SUBJECT: THREE MILE ISLAND, UNIT 1 (TMI UNIT 1)
OPERATING LICENSE NO. DPR-50
DOCKET NO. 50-289
LICENSE AMENDMENT REQUEST NO. 308 - Revision 1
PRESSURE TEMPERATURE OPERATING CURVES

TMI Unit 1 Revised License Amendment Request No. 308

Affected TMI Unit 1 Technical Specification Pages

TMI-1 29 EFPY PT Limits

Figure 3.1-1
Reactor Coolant System Heatup/Cooldown Limitations
[Applicable through 29 EFY]

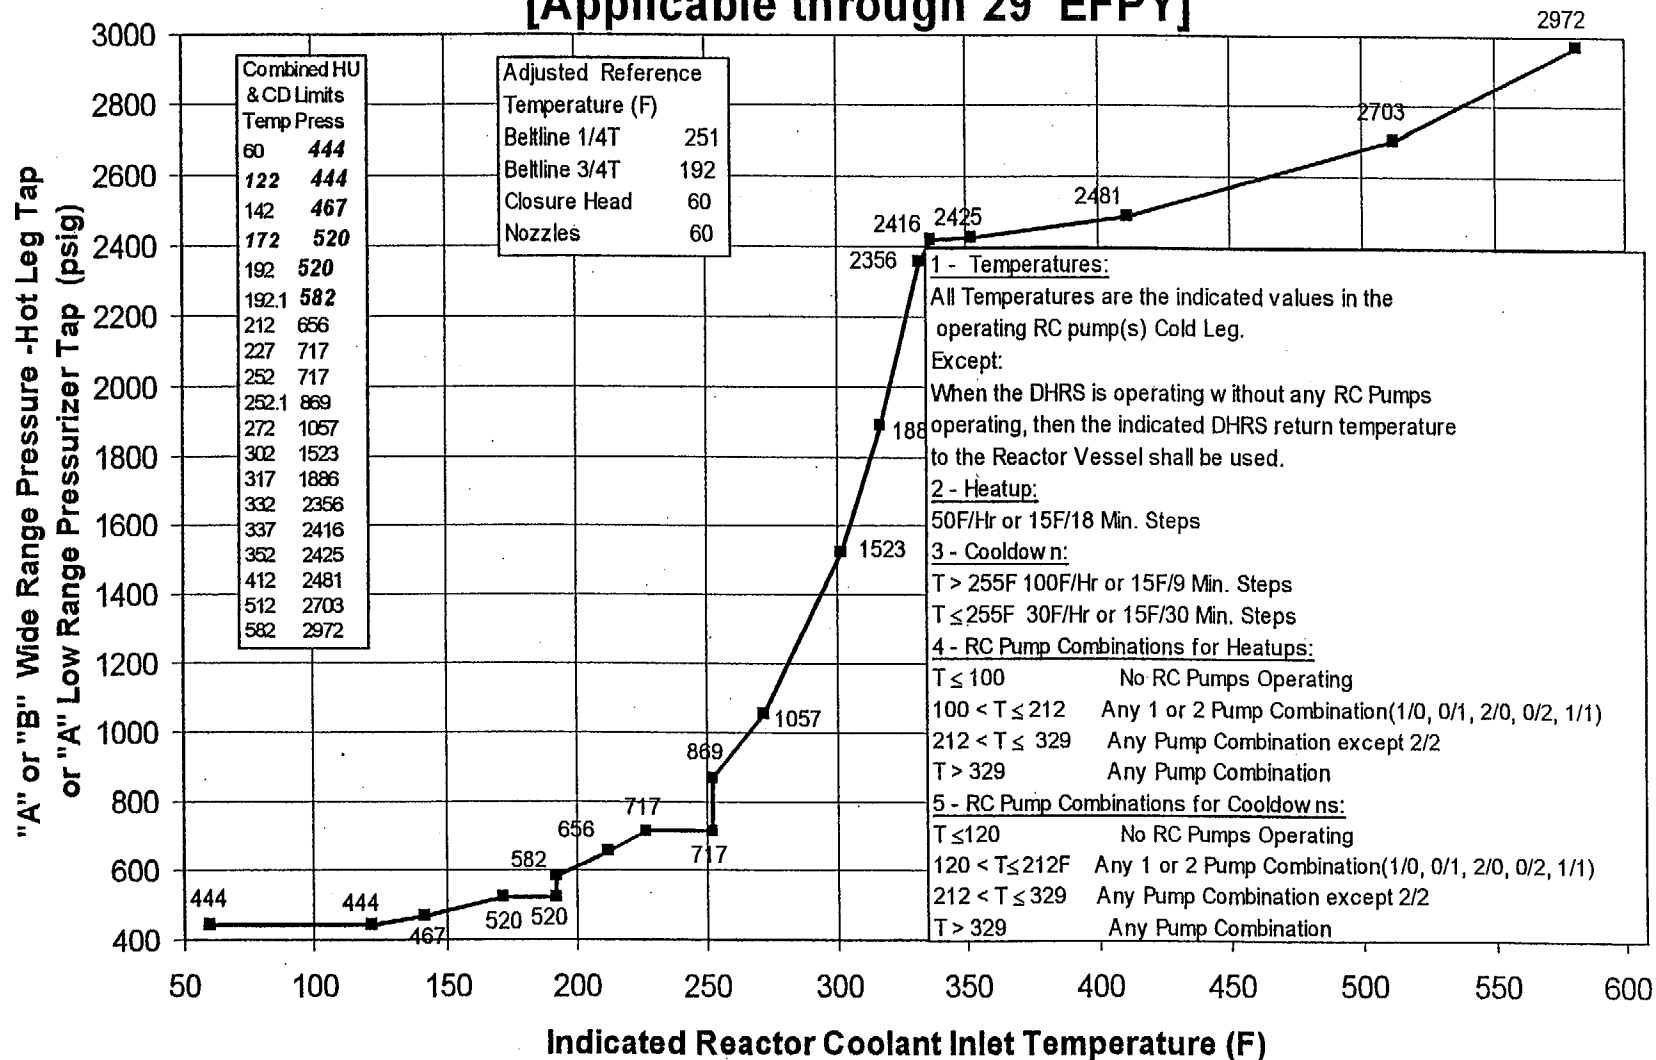
The previous submittal (reference 1) had the cooldown transition temperature to no RC pumps at 190°F. This revision changes that transition temperature to 120°F to allow for expanded use of the RC pumps during cooldown that can result in the reduction in outage critical path time while reducing RCP impeller wear from cavitation with only one pump in operation and thus maintaining plant safety. This change requires revision of Enclosure 2 to the reference 1 submittal. This revised Framatome ANP report is included as Enclosure 2 to this letter. This revision of the RC pump trip transition temperature to 120°F was evaluated in accordance with the same methodology, criteria, and input parameters (with the exception of the 190°F transition temperature) as the reference 1 submittal. It should be noted that, while several of the data tables and supporting curves within the Enclosure 2 report changed as a result of this change, the overall composite curves which form the basis for the Technical Specification Figures 3.1-1 and 3.1-2 are only revised to incorporate the effects of the RC pump trip transition temperature change at 120°F rather than 190°F (which includes the additional RC pump combination requirement for cooldowns between 212°F and 120°F identified on Technical Specification Figures 3.1-1 and 3.1-2), and the resulting pressure/temperature coordinate changes for the remainder of the composite curve below 120°F. As stated above, the technical basis for the revised portion of the heatup/cooldown limit curves provided in the enclosed revised Technical Specification Figures 3.1-1 and 3.1-2 remains consistent with the calculation methods, criteria and input utilized to develop the reference 1 submittal curves. The revised sections within the Enclosure 2 report are annotated to aid the review of this revision.

The change from 190° F to 120° F is necessary to provide additional cooling to the primary system through the extended use of the RC pumps during the plant cooldown. This additional cooling reduces the outage critical path by an estimated approximately 60 hours when compared to the more restrictive 190°F temperature transition limit requested in reference 1 and maximizes two-pump operation during cooldowns to avoid cavitation wear as described above. This change revises Technical Specification pages 3-5 (Bases), 3-5a and 3-5b from the reference 1 submittal. The only change to page 3-5 is to

CHANGE
 PER THIS
 REVISION

Figure 3.1-2
Reactor Coolant Inservice Leak Hydrostatic Test
[Applicable through 29 EFY]

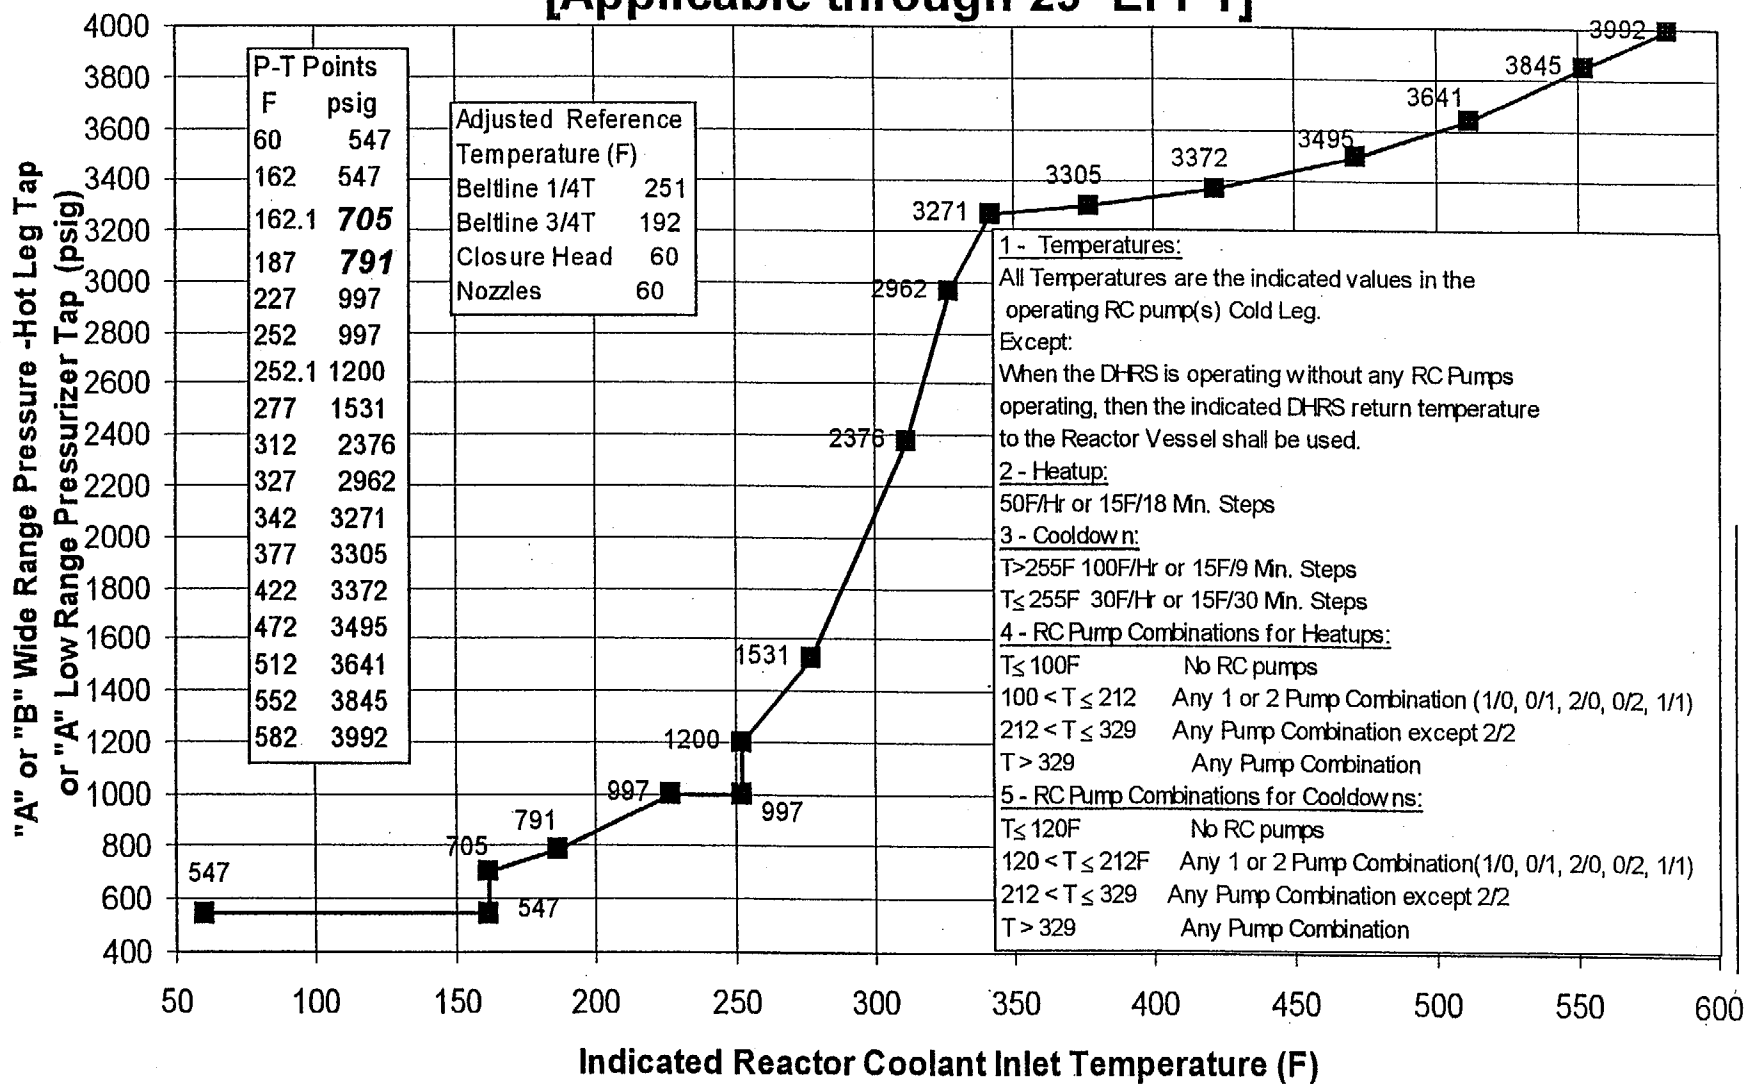
CHANGE
 PER THIS
 REVISION
